**CONTRACT DOCUMENTS & TECHNICAL SPECIFICATIONS
ADDENDUM NO. 2**

**DELAWARE BAYSHORE BYWAY
LITTLE CREEK BOARDWALK AND WILDLIFE VIEWING TOWER
CONTRACT NO. FW-2-15**

Date of Issue: December 19, 2018

4 DETAIL @ HANDRAIL SCALE: 1 1/2"=1'-0"
5 PLAN DETAIL @ HANDRAIL SCALE: 1 1/2"=1'-0"

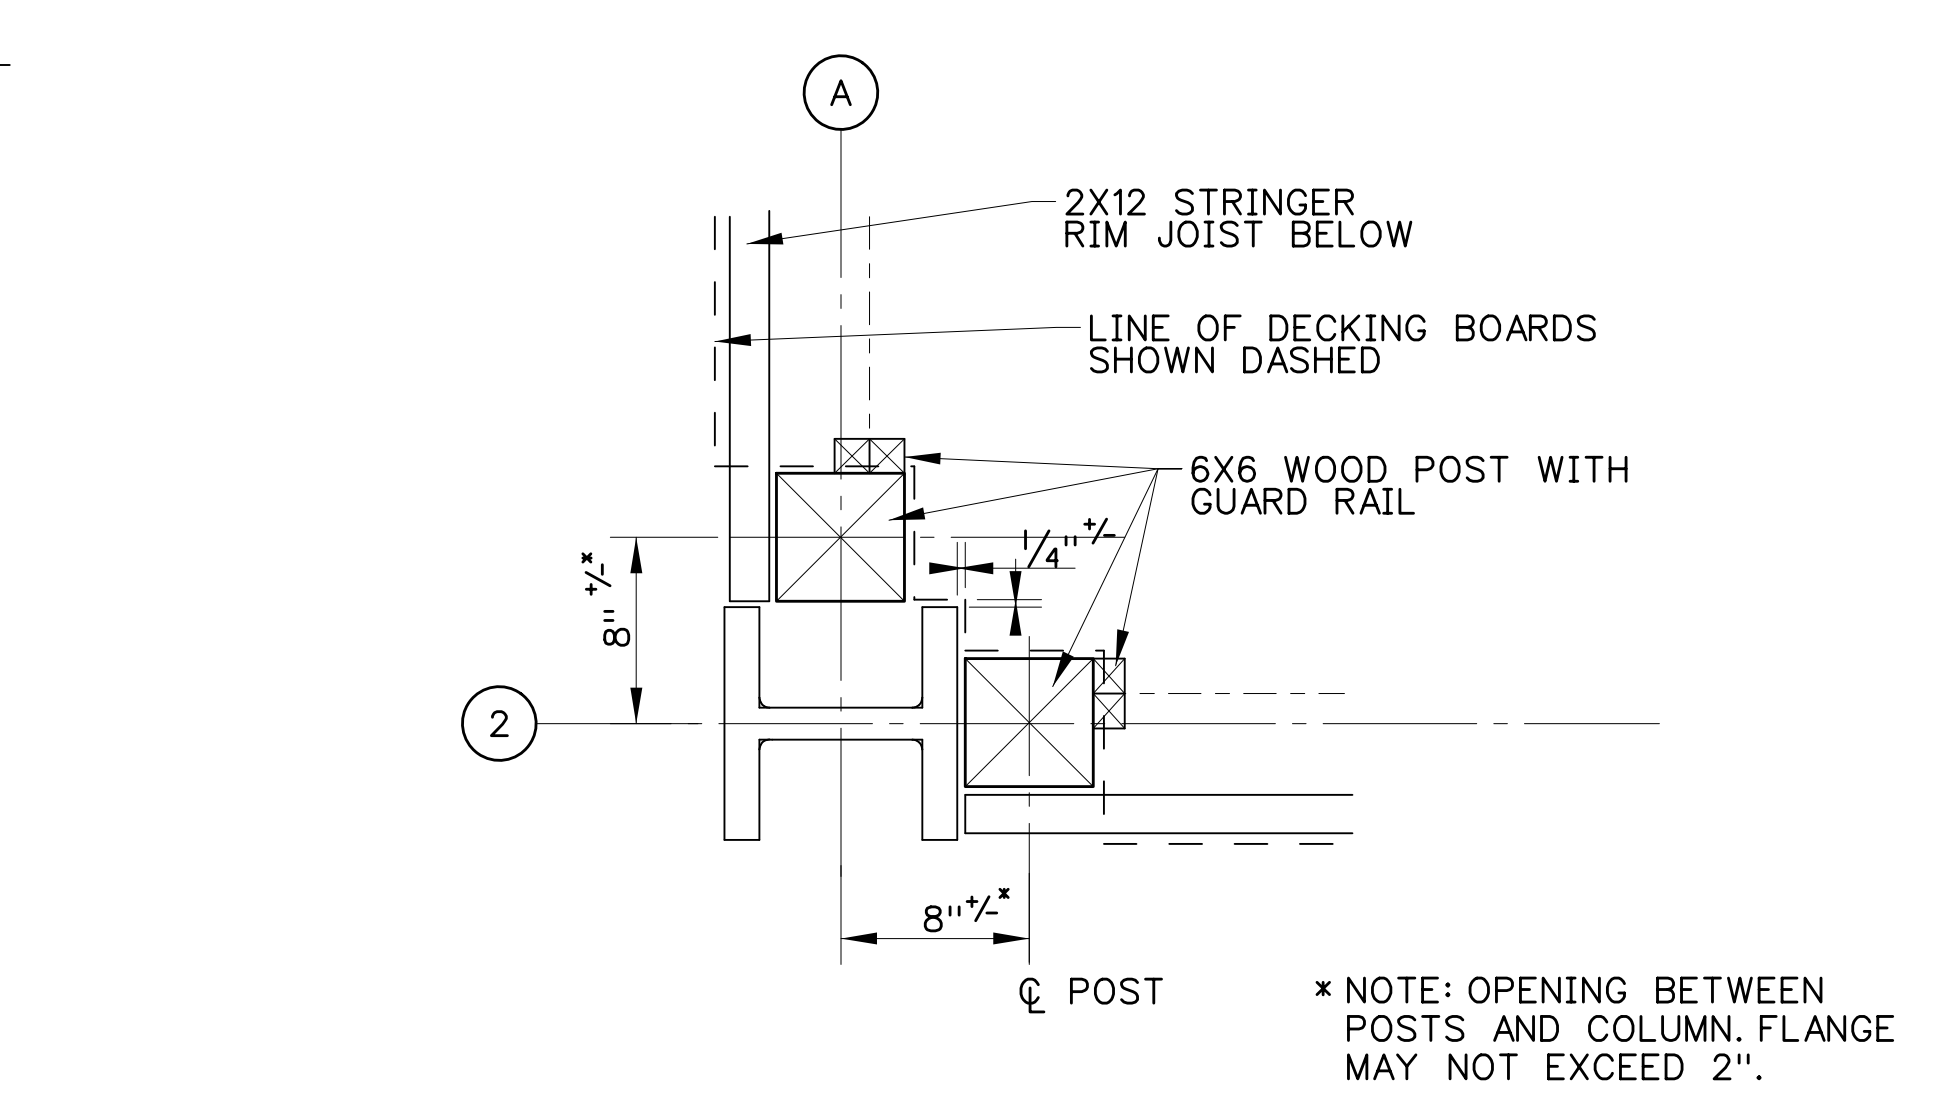
- Q6. Alternate 3 requires to complete railing system, will this be the complete rail as shown on Drawing-S8? Details 21, 22 and 23 are just the hand rail.

- A6. **Add/Alternate 3 includes furnishing and installing a round tube railing, matching the railing on the stairs see detail 4/A-3, around the perimeter of the upper level. Detail 4/A-3 has been revised to provide a round steel pipe handrail.**
